# **FINAL ENVIRONMENTAL STATEMENT**

## **HAVASU INTAKE CHANNEL HAVASU PUMPING PLANT AND BUCKSKIN MOUNTAINS TUNNEL**

FES 73 - 2 1

*Prepared by*  
**DEPARTMENT OF THE INTERIOR**  
*Bureau of Reclamation*

Figure 12

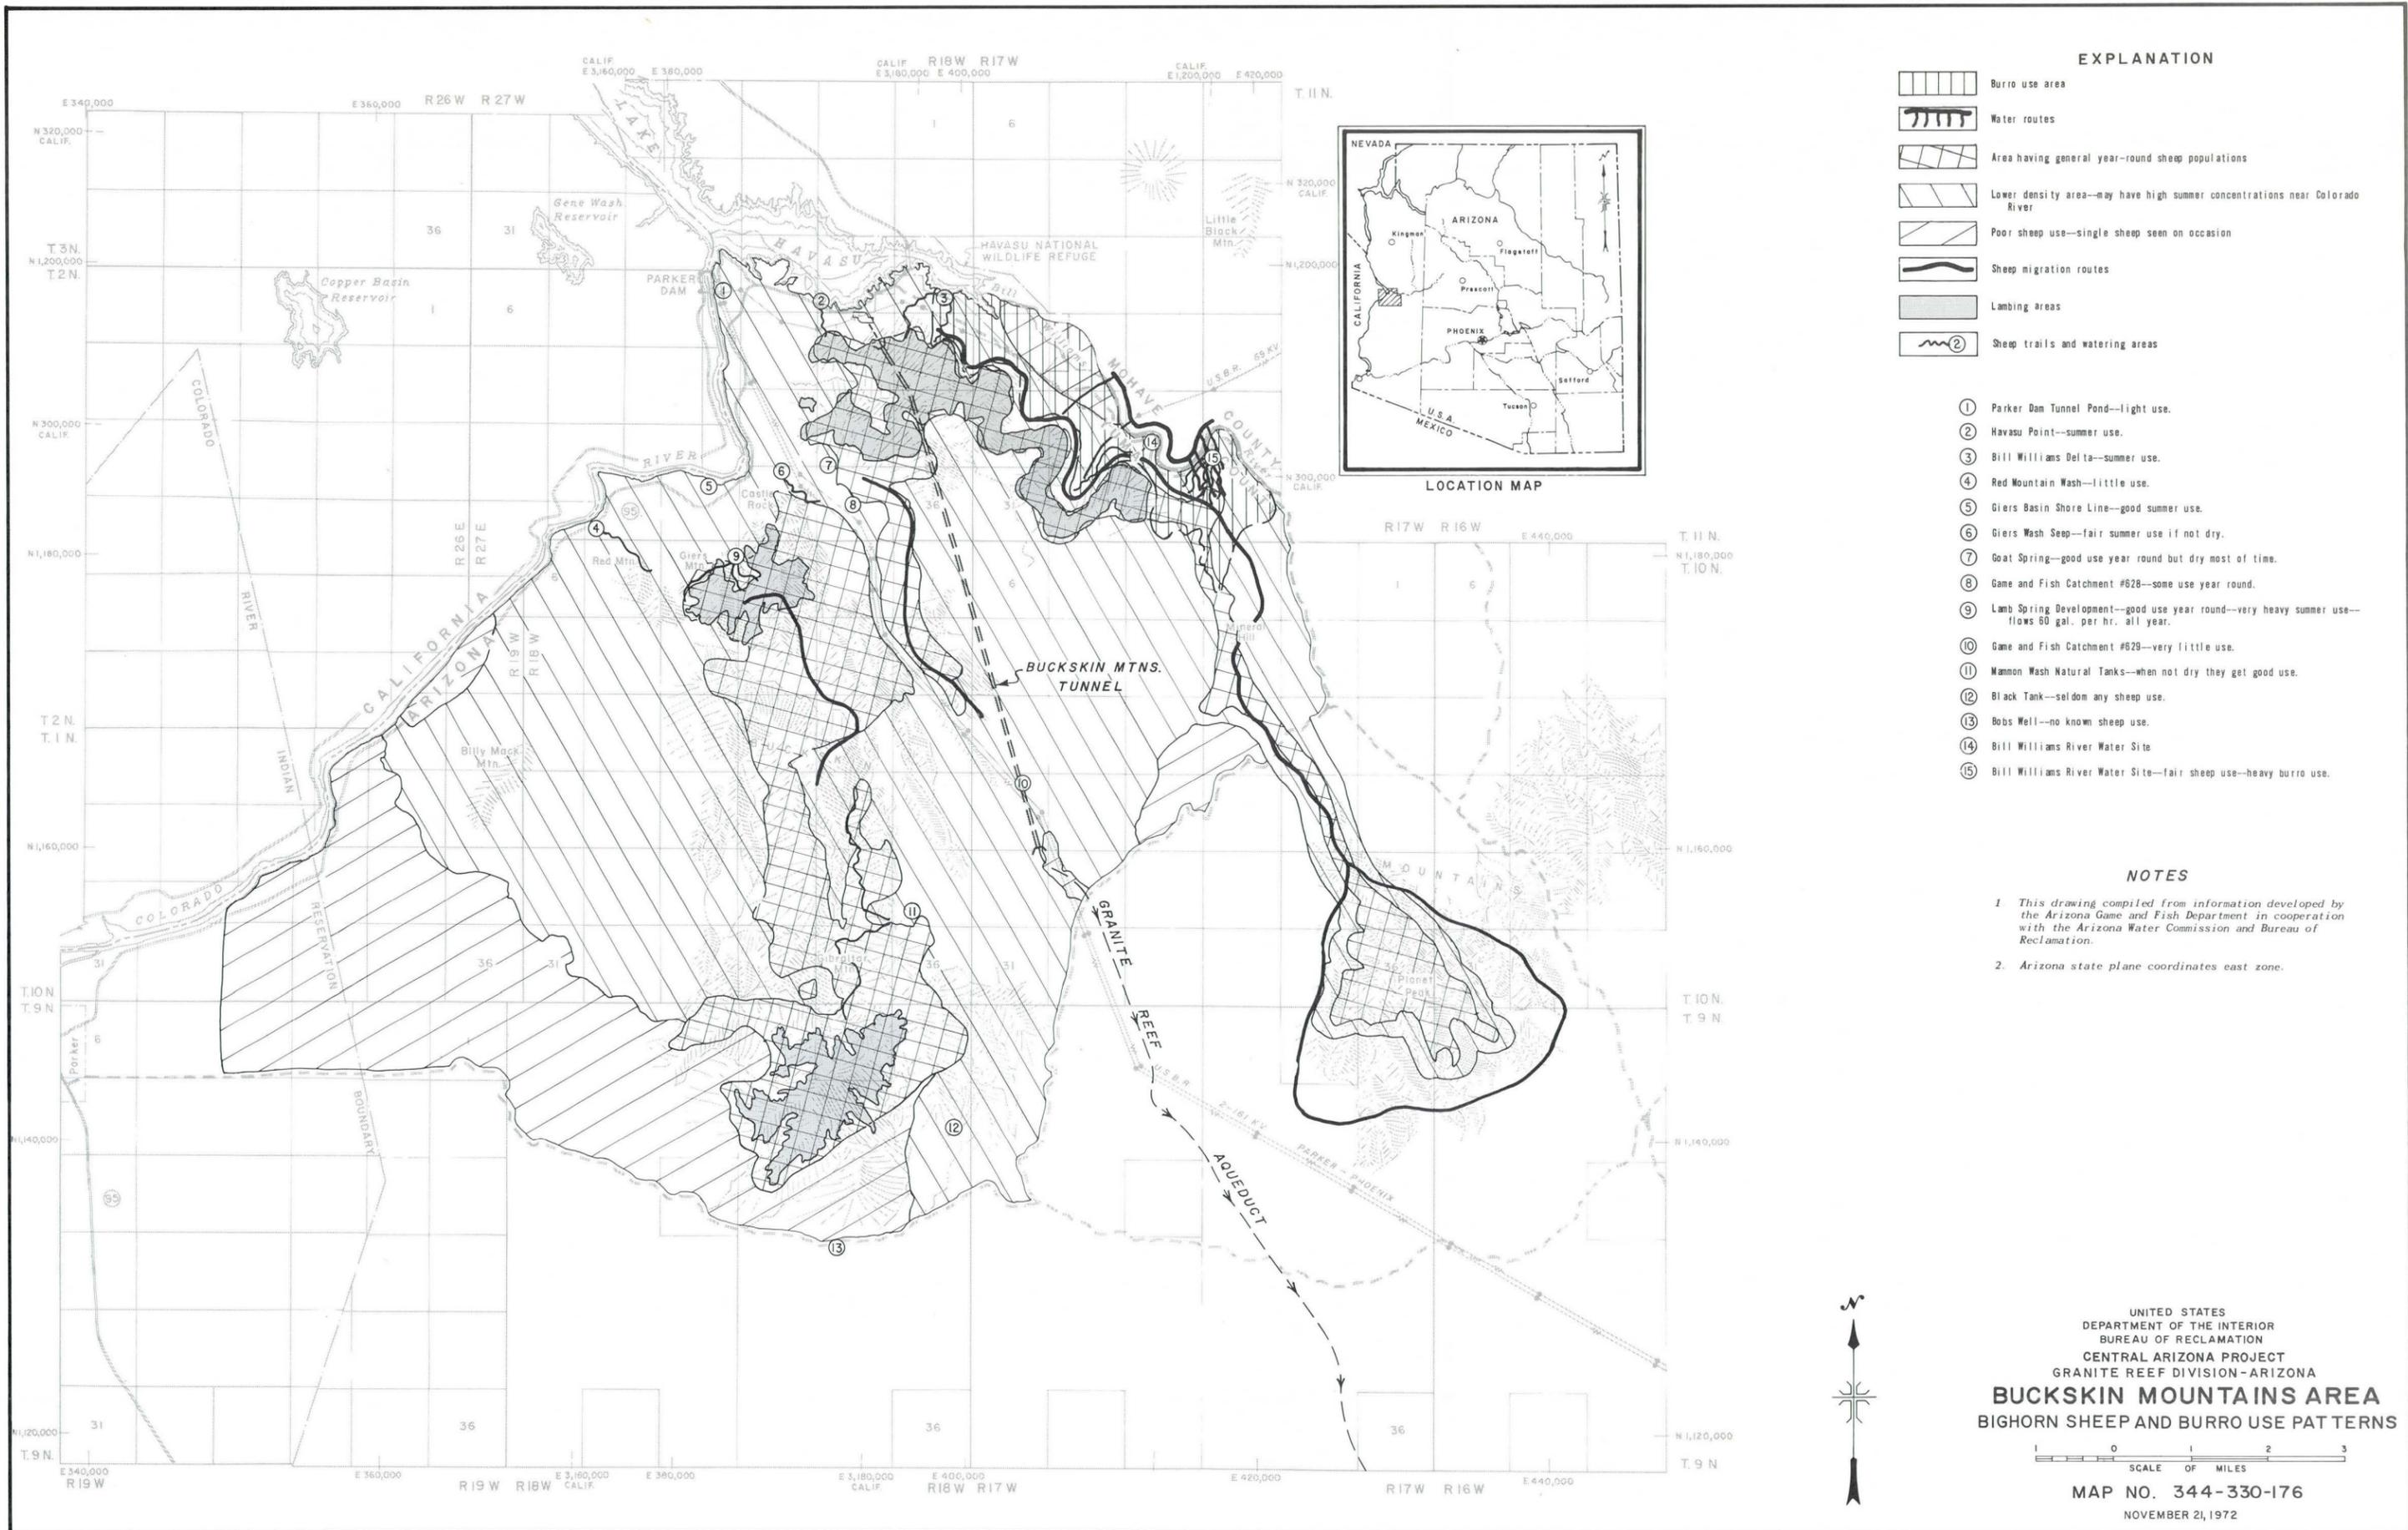
habitat evaluation portion of the study shows that the area along the tunnel alignment has the lowest value of three habitat sectors mapped. (See Chapter II., Figure 12.)
